ADDENDUM NO. 1

**JACKSON ELEMENTARY SCHOOL RENOVATIONS
Valparaiso, IN 46304**

This Addendum consists of page ADD 1-1 and attached Addendum No. 1 from Gibraltar Design dated November 9, 2022 and consisting of 4 pages and 29 drawings.

Addendum One (AD.01) to the drawings and specifications prepared by Gibraltar Design for **Jackson Elementary School Renovations** for Duneland School Corporation, Chesterton, Indiana.

A-101

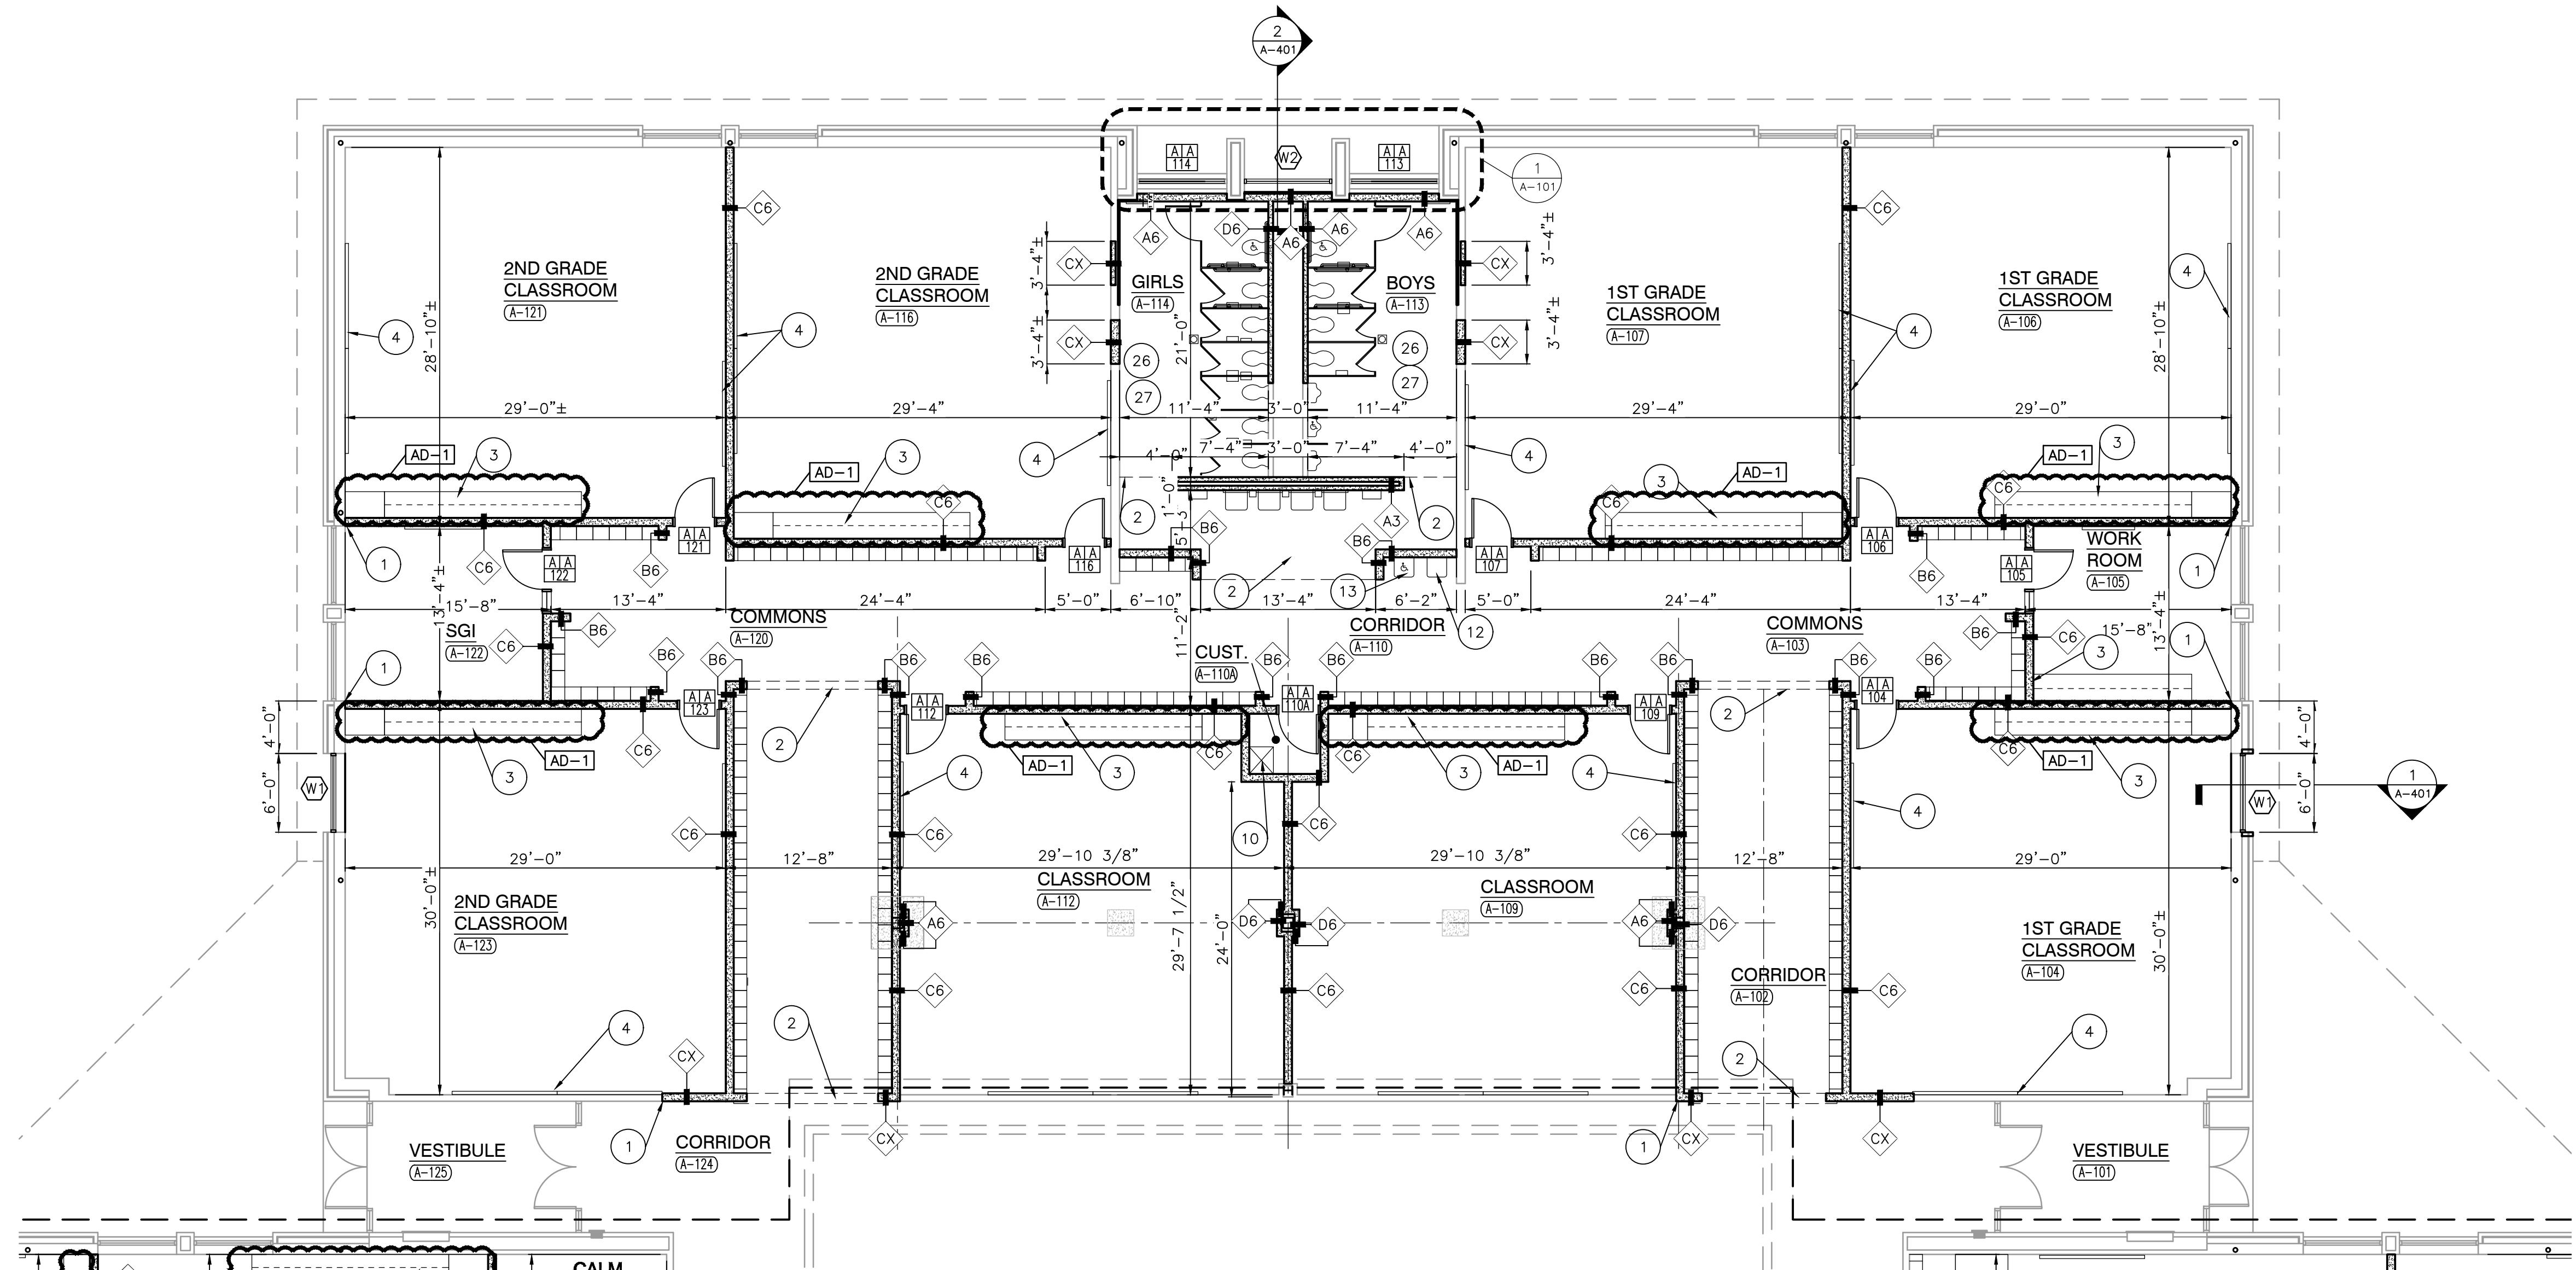
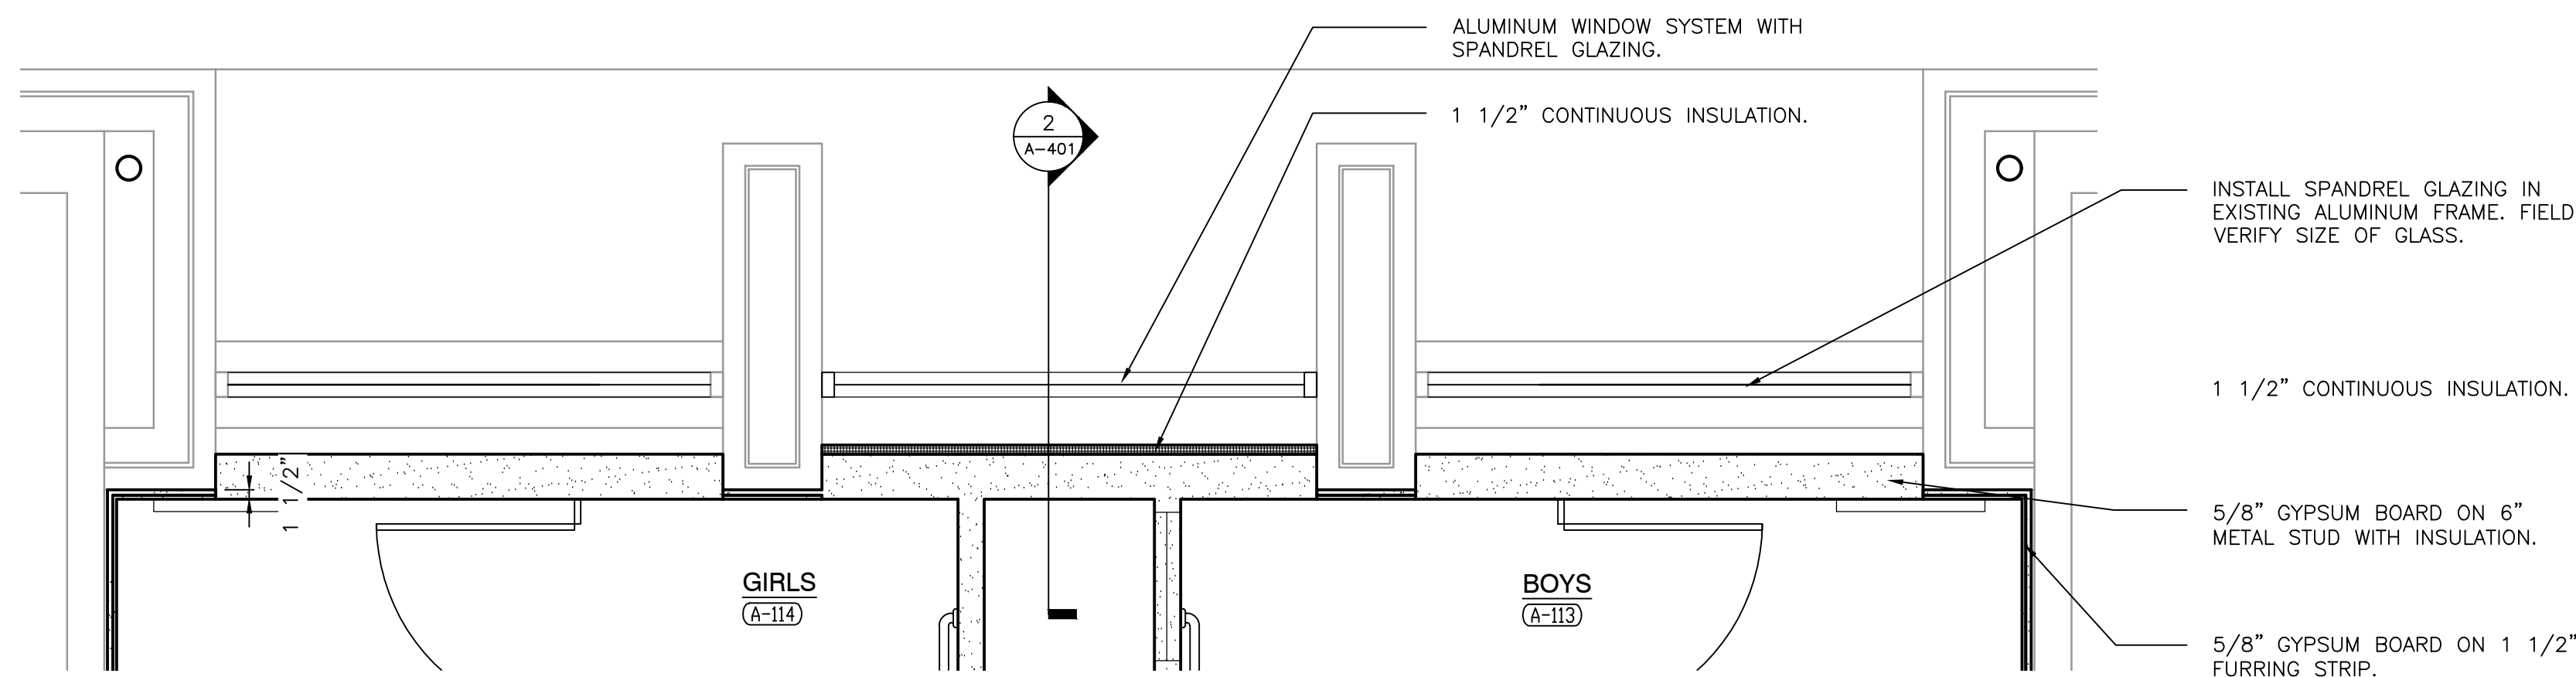
3. Sheets A-101 and A-102

- A. Refer to two (2) revised full size drawings, included in this Addendum, for the following revisions:
 - 1. Updated casework throughout to coordinate with Equipment plans.
 - 2. Updated floorplan to include Commons B-125B, Toilet B-119A, and Toilet B-119B.
